No. EL/3.1.35/2/Elect

MODIFICATION SHEET NO. RDSO/2012/EL/MS/0413, Rev. '1' Dated 25.04.2016

Paralleling of interlocks of EP contactors and auxiliary contactors of three phase locomotives to improve reliability.

SCHEMATIC POSITION : 52.5/1
 Contactor Oil Pump-1

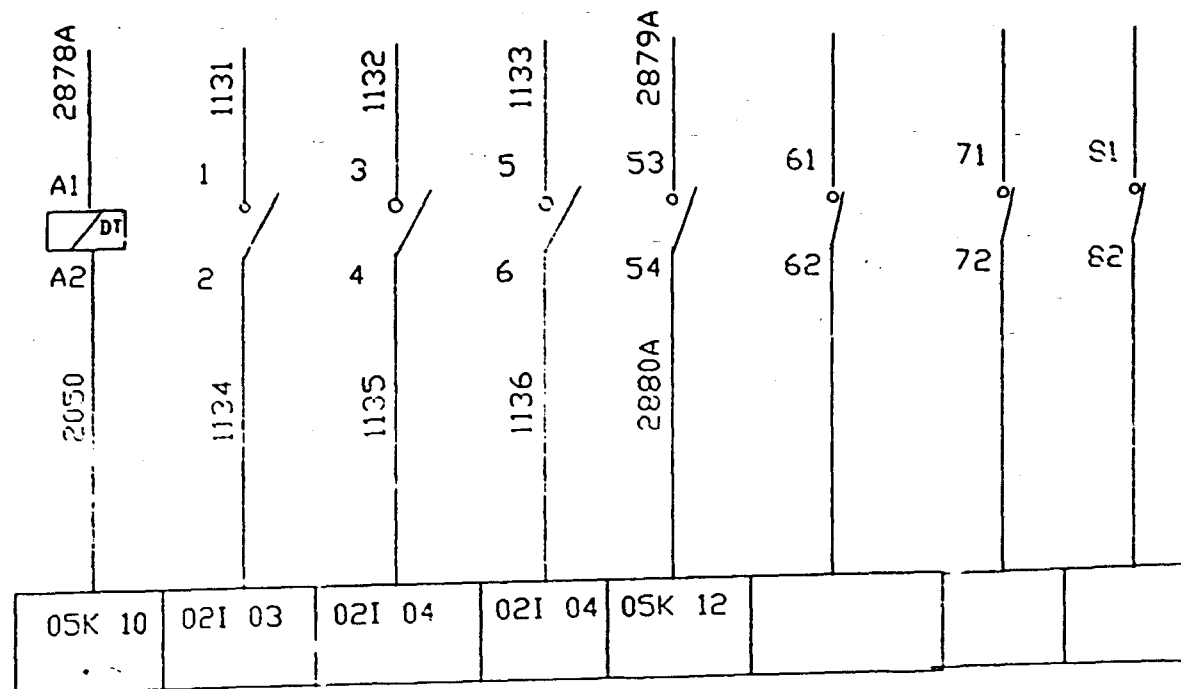
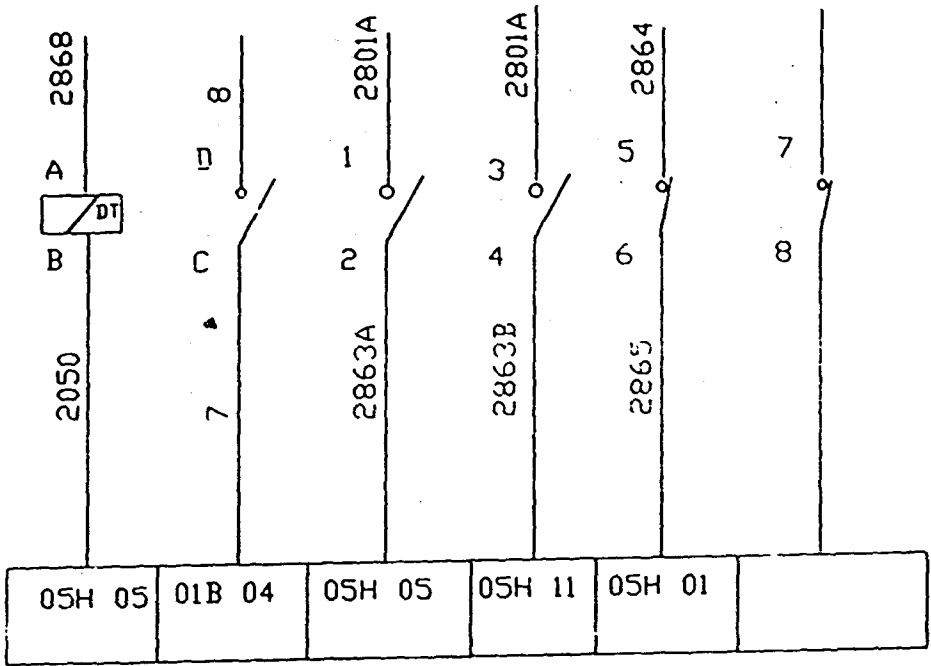
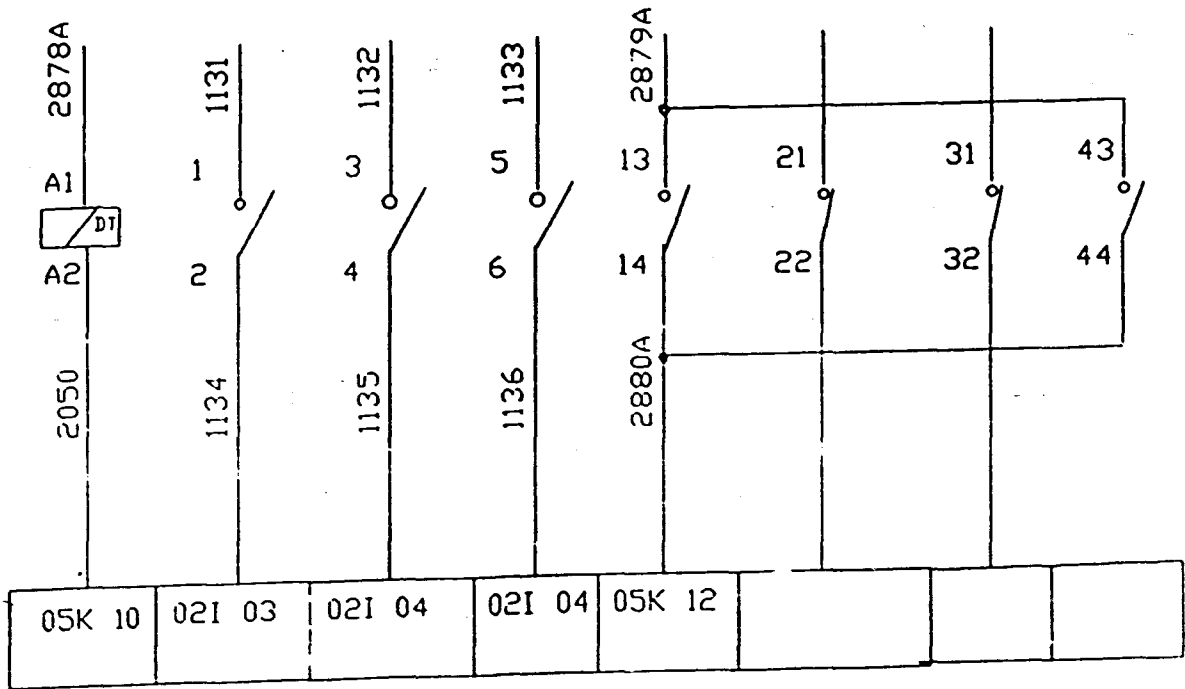
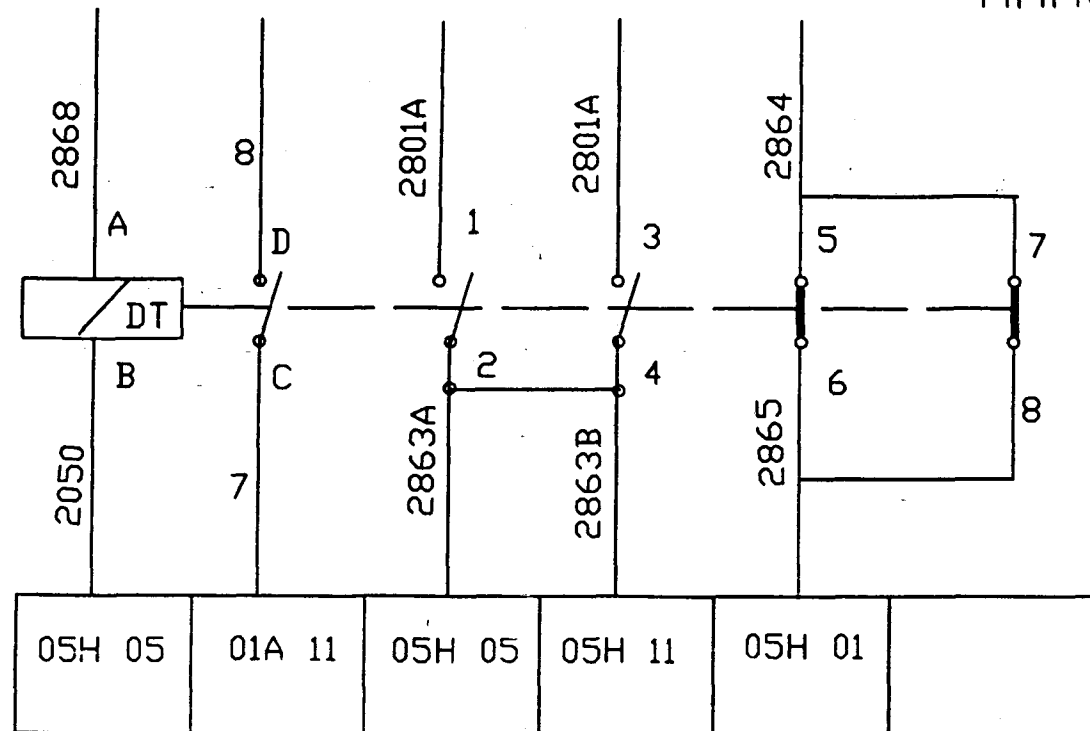
paralleled with used NO I/L 13-14.
6.	52.5/1 & 2*	Contactor oil pump	Replaced by LADN-22 of sch. pos. 126.7/1 & 2	01 NO	01 NO + 02 NC	HB-2	In place of LADN-13, LADN-22 is to be used hence the spare NO I/L 43-44 is to be paralleled with used NO I/L 13-14.
7.	126.7/1 & 2*	Contactor power supply cab	01 NO + 01 NC	Replaced by LADN-13 of sch. pos. 52.5/1 & 2	02 NC	SB-1 /SB-2	Cable no. 2097 A and 2099A are connected across NO I/L 53-54 and cable no. 2503B and 2504B are connected across NC I/L 61-62 for 126.7/1. Similarly circuit to be modified for 126.7/2.
8.	8.41	Contactor discharging resistor	02 NO + 01 NC	01 NC	FB	The spare NC interlock 7-8 is to be paralleled with used NC interlock 5-6, connect cable no. 2863A & 2863B. For the modified circuit diagram refer to Rev. '1' modified schematic position: 8.41 of Annexure-2

*** to facilitate SN 6 and 7 above, the LADN-13 of contactor 52.5/1&2 to be interchanged with LADN-22 of 126.7/1&2.**

MODIFIED SCHEMATIC POSITION : 52.5/1
 Contactor Oil Pump-1

MODIFIED SCHEMATIC POSITION : 52.5/2
Contactor Oil Pump-2

SCHEMATIC POSITION : 8.41
Contactor For Discharging Resistor

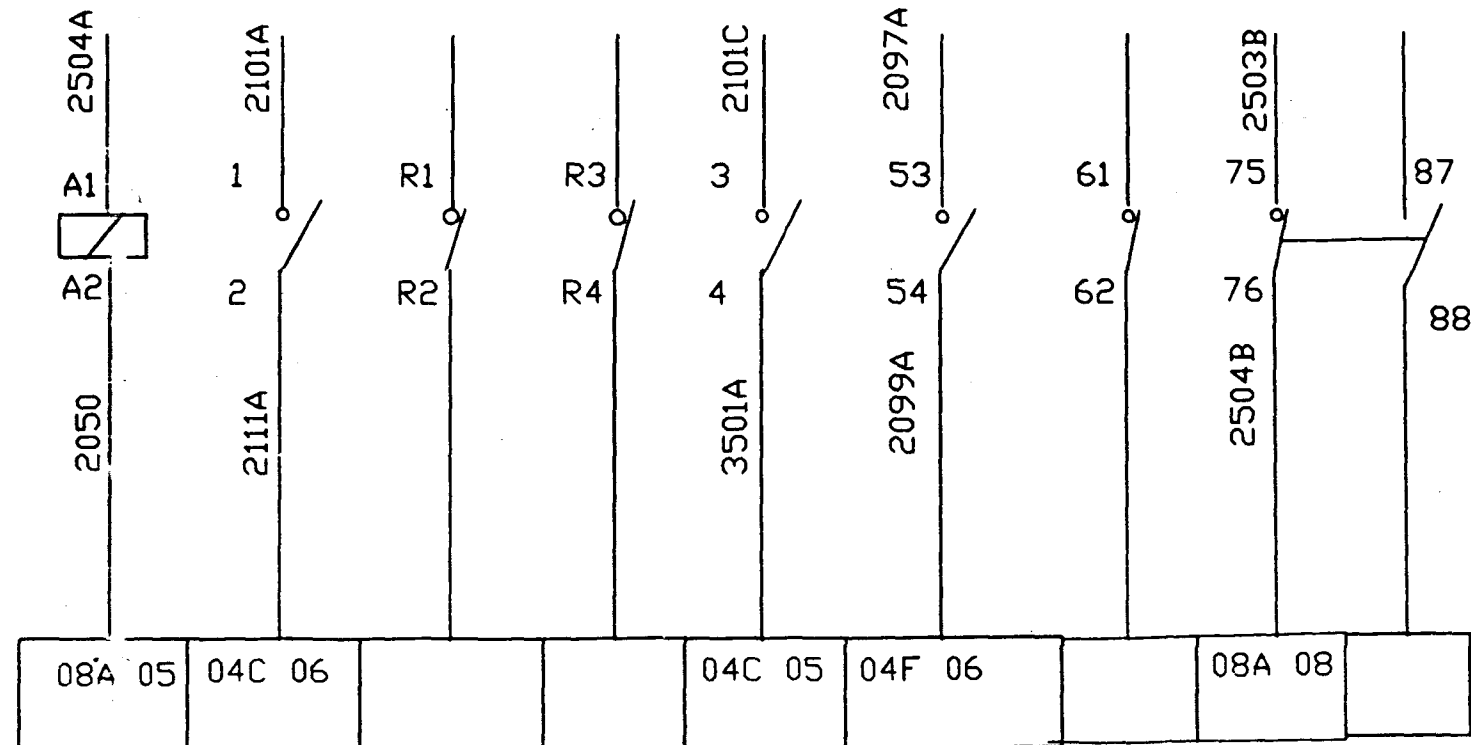
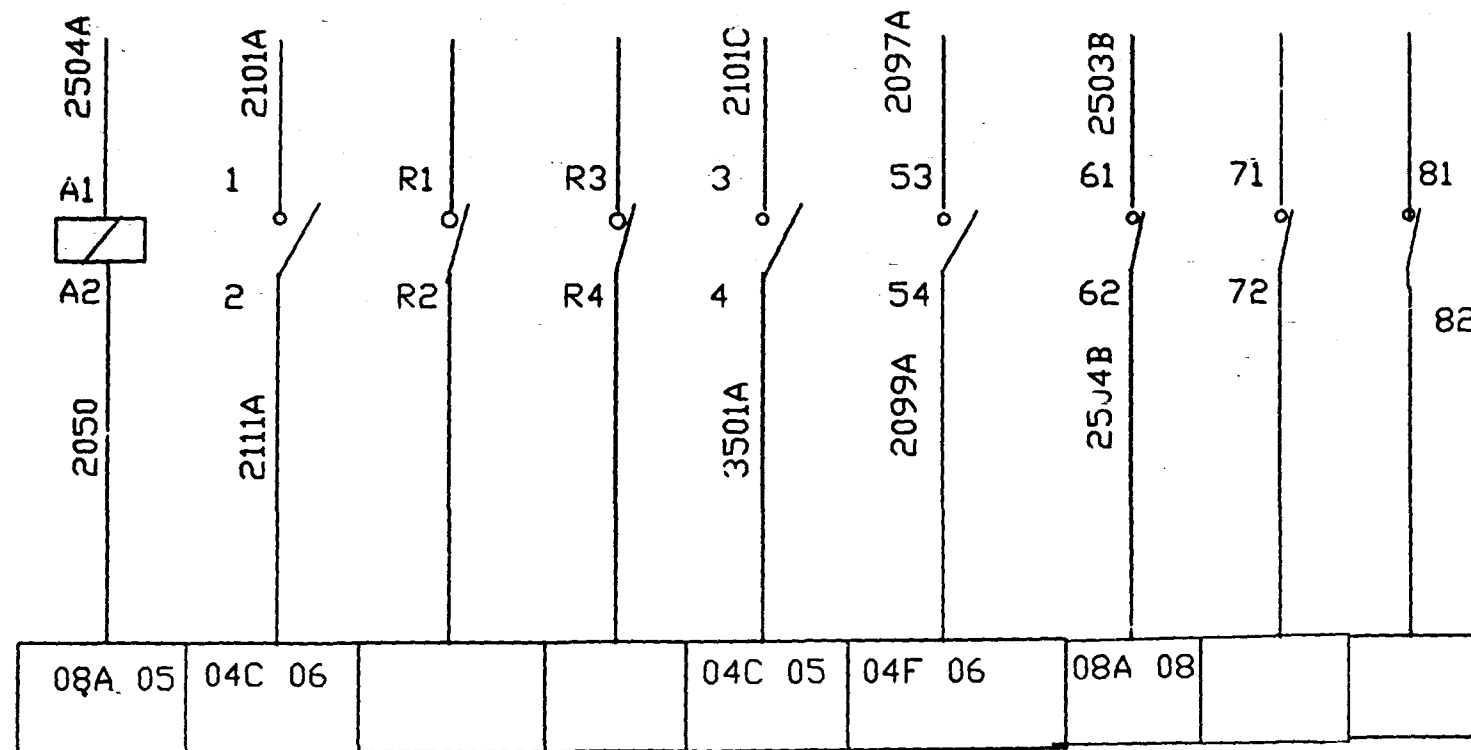
2.2 Further, S.C. Railway vide their letter no. C/E.221/ELS/LGD/Tech/27B dated 25.02.13 has suggested that instead of additional LADN-22 required for paralleling 52.5/1&2, it may be interchanged from 126.7/1&2 and paralleling of two NO interlocks of 8.41 may be achieved by shorting 2 & 4 terminal interlock available (normally only one contactor is used and other is not used, second interlock is used only when other Bogie is isolated) by providing an additional loop instead of asking the manufacturer to provide two additional NO interlocks. Thus, Rev.'1' of this Modification Sheet is issued.

Rev.'1' Modified Schematic Pos. 8.41
Contactor for discharge resistor
